UNITED STATES PATENT AND TRADEMARK OFFICE

APPLICATION NO.	FILING DATE	FIRST NAMED INVENTOR	ATTORNEY DOCKET NO.	CONFIRMATION NO.
10/814,348	04/01/2004	Serge Bisson	44117-138	5328
20277	7590	06/13/2006		EXAMINER
MCDERMOTT WILL & EMERY LLP 600 13TH STREET, N.W. WASHINGTON, DC 20005-3096			GABLER, PHILIP FRANCIS	
			ART UNIT	PAPER NUMBER
			3637

Office Action Summary	Application No.	Applicant(s)	
	10/814,348	BISSON ET AL.	
	Examiner	Art Unit	
	Philip Gabler	3637

DETAILED ACTION

Exhibit 1: Bitel '773 Figures 1 and 3

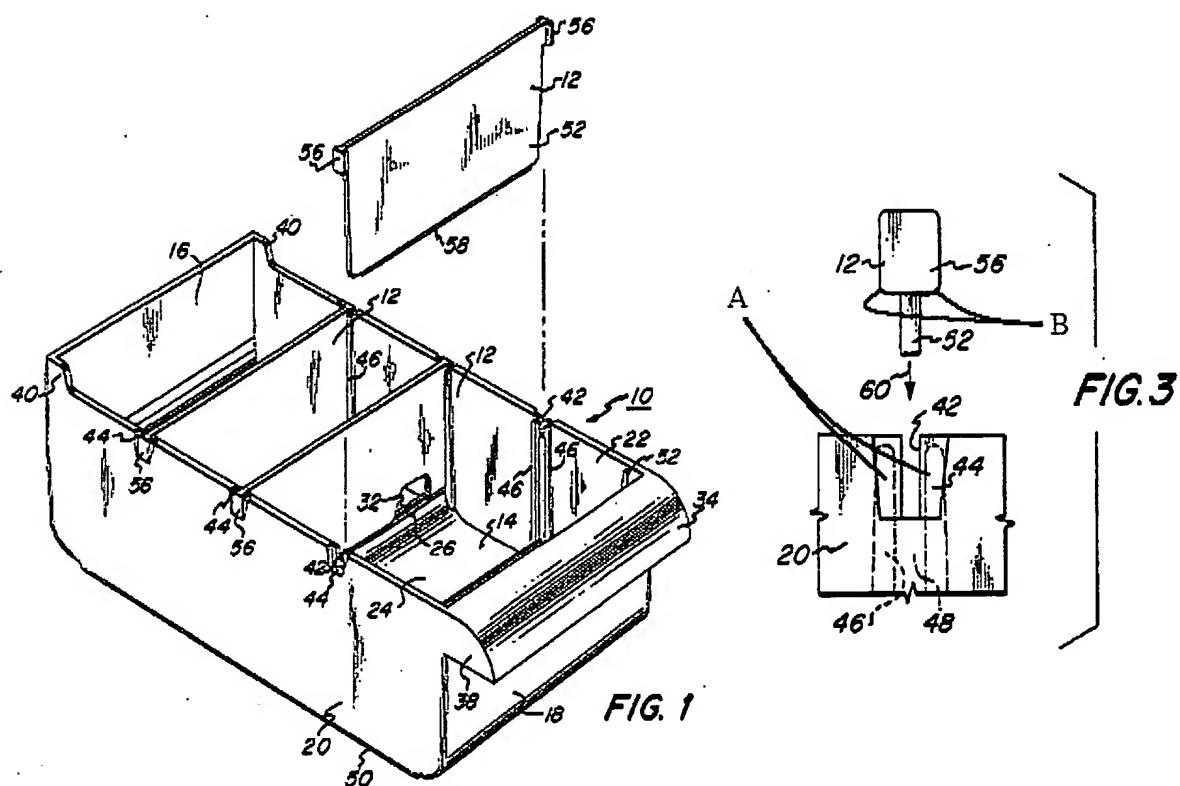
10. Regarding claims 1 and 13, Bitel (Figures 1 and 3) discloses a partitioning/fastening arrangement for a partitioning wall in a drawer comprising: a partitioning wall (12) having a pair of elongated blades (56) in the partitioning wall [Note that the limitation "punched" is a product by process limitation. The product itself does not depend on the process of making it. The limitation "punched" would not be expected to impart distinctive structural characteristics to the device.] and projecting sideways from the partitioning wall adjacent ends thereof at a predetermined height of the partition wall, each blade extending vertically along a corresponding adjacent end of the partitioning wall and comprising a lower ramp surface (viewed as angles B) defined

by the partitioning wall and said predetermined height; and opposite connecting elements (42, 44, and surrounding area) respectively projecting from the support walls at heights matching with the height of the blades of the partitioning wall when the partitioning wall is in operative position between the support walls (20, 22), the connecting elements having retaining channels (42, 44) in which the ends of the partitioning wall are uprightly slideably engageable, the retaining channels having opposite side locking lips (viewed as A in Exhibit 1) forming guiding slots for passage of a section of the partitioning wall extending between the connecting elements, the ramp surfaces of the blades of the partitioning wall being shaped and sized for facilitating insertion of the blades in the retaining channels and for respectively and progressively press-fitting against inner sides of said channels behind the locking lips when the partitioning wall is in the operative position (the press-fit would be progressive based on the shape of 44 of the retaining channel).

11. Regarding claims 2 and 14, Bitel further discloses opposite support elements (46) respectively projecting from the support walls at another height with respect to the connecting elements, the support elements respectively having guiding slots (48) in which the ends of the partitioning wall are slideably engageable, the guiding slots of the support elements being aligned with the guiding slots of the retaining channels of the connecting elements (see Figure 3).

12. Regarding claims 5 and 16, Bitel further discloses the support elements extend below the connecting elements (see Figure 1).

14. Regarding claims 8 and 19, Bitel further discloses a seating flange (58) projecting from a bottom end of the partitioning wall and extending laterally with respect thereto.

Exhibit 2: Hollenstein '742 Figures 1 and 2

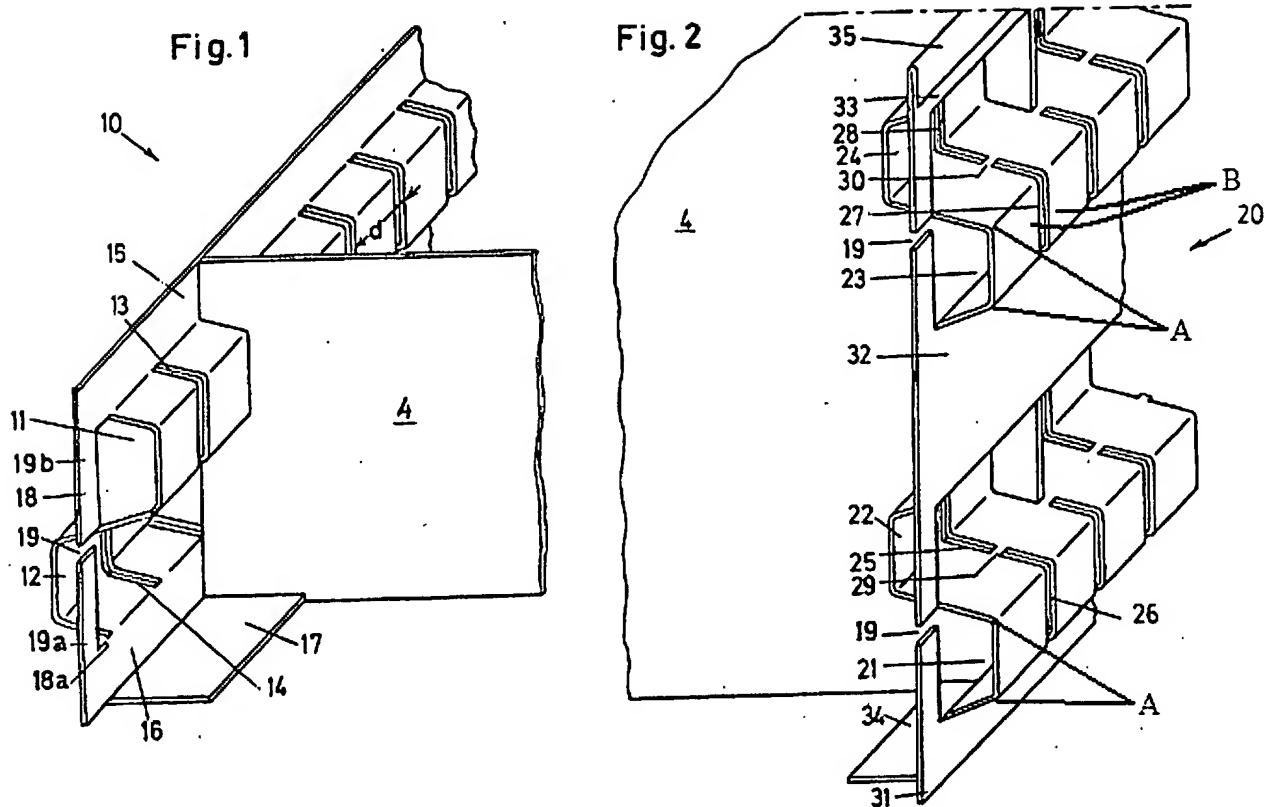
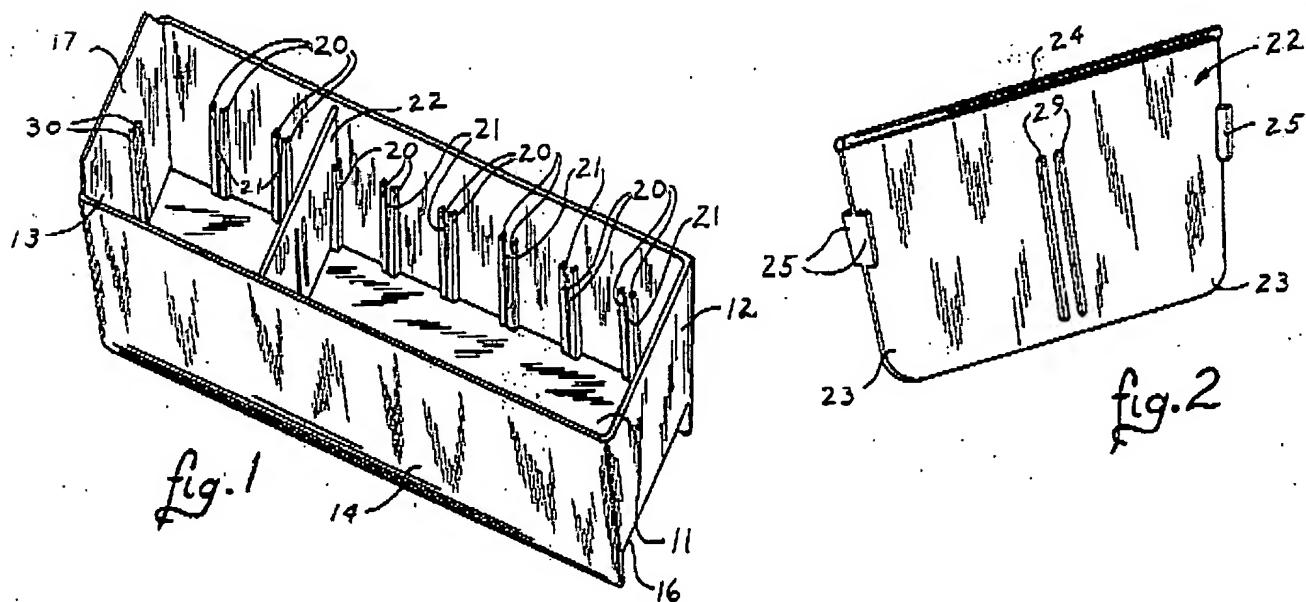
17. Regarding claims 1 and 13, Hollenstein (Figures 1 and 2) discloses a drawer partition system comprising a partitioning wall (4); and opposite connecting elements (23, 27) respectively projecting from support walls (32, note that while only one support wall is shown, it is inherent that more would be present in a drawer arrangement) at heights matching with the height of a partitioning wall (4) when the partitioning wall is in operative position between support walls, the connecting elements having retaining channels (27) in which the ends of the partitioning wall are uprightly slideably engageable, the retaining channels having opposite side locking lips (viewed as B in Exhibit 2) forming guiding slots for passage of a section of the partitioning wall extending between the connecting elements. Hollenstein does not disclose a pair of blades in the partitioning wall. Bitel discloses a partition arrangement for a drawer including elongated blades (56) in a partitioning wall and projecting sideways from the partitioning wall adjacent ends thereof at a predetermined height of the partition wall, each blade extending vertically along a corresponding adjacent end of the partitioning wall and comprising a lower ramp surface (viewed as angles B) defined by the

18. Regarding claims 2 and 14, Hollenstein further discloses opposite support elements (21, 26) respectively projecting from the support walls at another height with respect to the connecting elements, the support elements respectively having guiding slots (26) in which the ends of the partitioning wall are slideably engageable, the guiding slots of the support elements being aligned with the guiding slots of the retaining channels of the connecting elements (see Figure 2).

19. Regarding claims 3 and 15, Hollenstein further discloses the connecting (23, 27) and support (21, 26) elements comprising longitudinal extrusions (21, 23) made in the support walls (32) and projecting on a side thereof, with retaining channels (27) and guiding slots (26) being made in and extending crosswise to the extrusions of respective ones of the connecting and support elements.

20. Regarding claim 4, Hollenstein further discloses the extrusions have substantially rounded upper and lower surfaces (viewed as curves A in Exhibit 2) for joining the support walls.

21. Regarding claim 9, Hollenstein further discloses an additional connecting element (24) projecting from at least one of the support walls at a height to receive a partitioning wall (4), the additional connecting element being like the connecting element

already made in said at least one of the support walls but projecting on a side of said at least one of the support walls opposite to a side on which the connecting element already made in said at least one of the support walls projects (see Figure 2).

22. Regarding claim 10, Hollenstein further discloses an additional connecting element (24) projecting from at least one of the support walls at a height to receive a partitioning wall (4), and an additional support element (22) projecting from said at least one of the support walls at another height with respect to the additional connecting element, the additional connecting and support elements being respectively like the connecting and support elements (21, 23, 26, 27) already made in said at least one of the support walls but projecting on a side of said at least one of the support walls opposite to a side on which the connecting and support elements already made in said at least one of the support walls project (see Figure 2).

23. Regarding claim 11, Hollenstein further discloses the connecting elements of said at least one of the support walls extend successively one above the other, and the support elements of said at least one of the support walls extend successively one above the other (see Figure 2).

Kleinert et al. '215 Figures 1 and 2

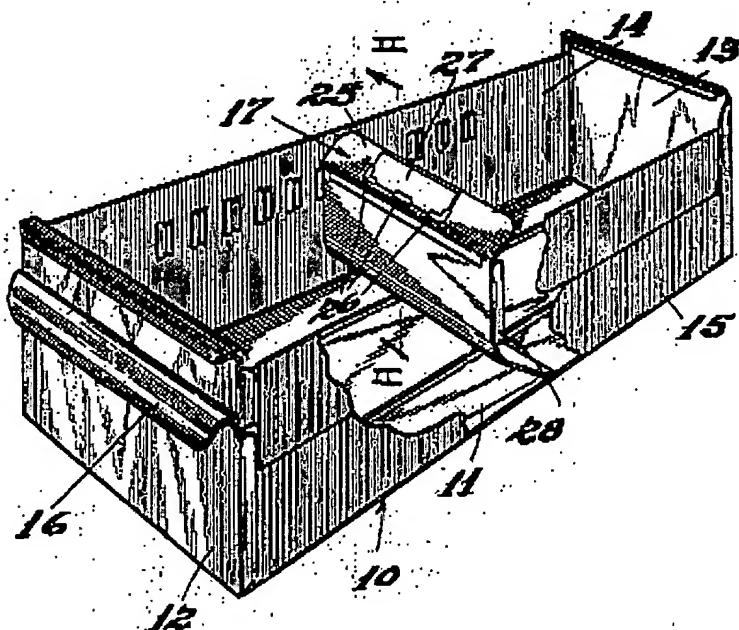
25. Claims 20-23 are rejected under 35 U.S.C. 103(a) as being unpatentable over Hollenstein in view Bitel and further in view of Kleinert et al. (US Patent Number 4436215). Hollenstein, when modified by Bitel as described above, discloses a partitioning system as recited in claim 14 as well as connecting and support elements as recited in claims 20-23, but does not disclose similar connecting and support elements on a partitioning wall in addition to the support walls. Kleinert (Figures 1 and 2) discloses a partition system for a drawer including a partitioning wall (22) comprising connecting/support elements (29) like the connecting/support elements (30) of his

support walls (13, etc.), the partitioning wall capable of forming a support wall for another partitioning wall. Accordingly, it would have been obvious to one of ordinary skill in the art at the time the invention was made to modify Hollenstein's partitioning wall, in his partitioning system previously modified by Bitel, to include connecting/support elements on his partitioning wall in addition to those on his support walls as taught by Kleinert because this would allow a more partitions to be added to the system and increase its versatility.
